Pentium[®] Pro Processor Specification Update

Release Date: March, 1997

Order Number 242689-017

Figure 4-3. Stack Switch on a Call to a Different Privilege Level

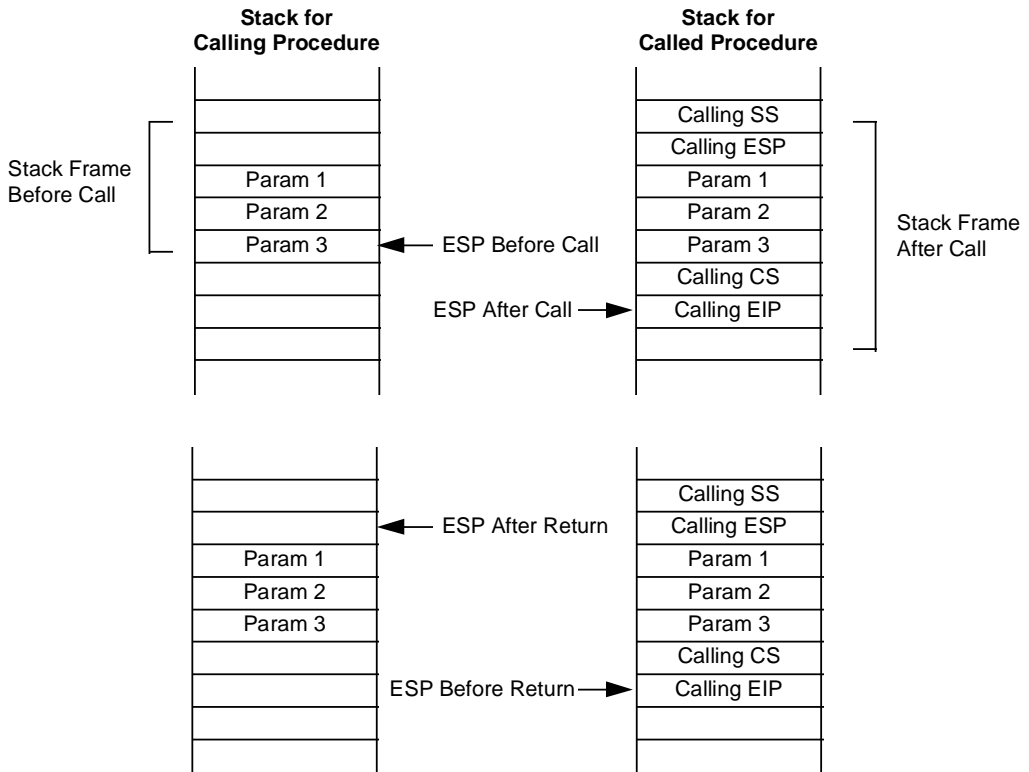
4.3.6. CALL and RET Operation Between Privilege Levels

When making a call to a more privileged protection level, the processor does the following (see Figure 4-3):

1. Performs an access rights check (privilege check).
2. Temporarily saves (internally) the current contents of the SS, ESP, CS, and EIP registers.
3. Loads the segment selector and stack pointer for the new stack (that is, the stack for the privilege level being called) from the TSS into the SS and ESP registers and switches to the new stack.

4. Pushes the temporarily saved SS and ESP values for the calling procedure's stack onto the new stack.
5. Copies the parameters from the calling procedure's stack to the new stack. (A value in the call gate descriptor determines how many parameters to copy to the new stack.)

Figure 4-4. Stack Usage on Transfers to Interrupt and Exception Handling Routines

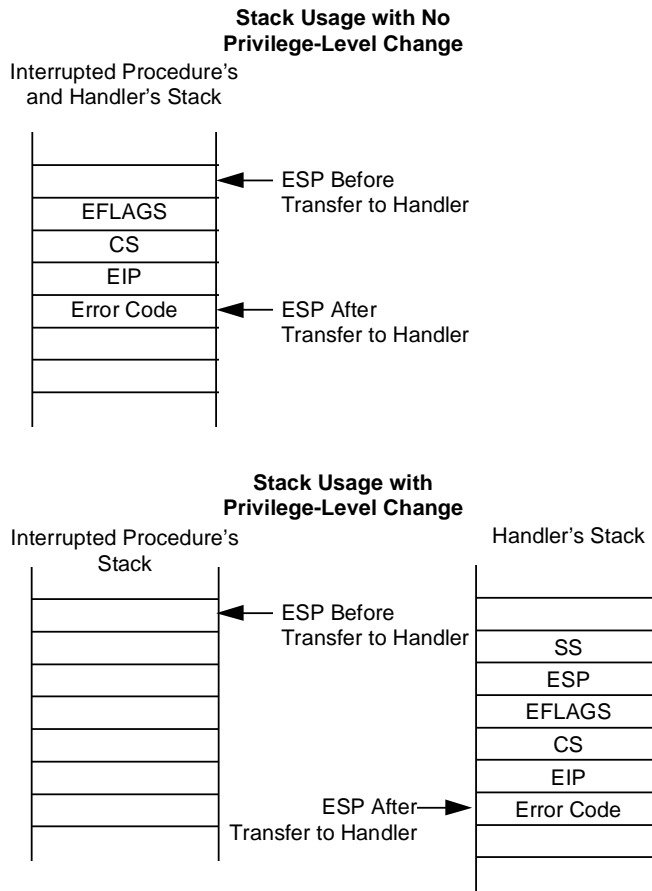
If no stack switch occurs, the processor does the following when calling an interrupt or exception handler (see Figure 44):

1. Performs a privilege check.
2. Restores the CS and EIP registers to their values prior to the interrupt or exception.
3. Restores the EFLAGS register.
4. Restores the SS and ESP registers to their values prior to the interrupt or exception, resulting in a stack switch back to the stack of the interrupted procedure.
5. Resumes execution of the interrupted procedure.
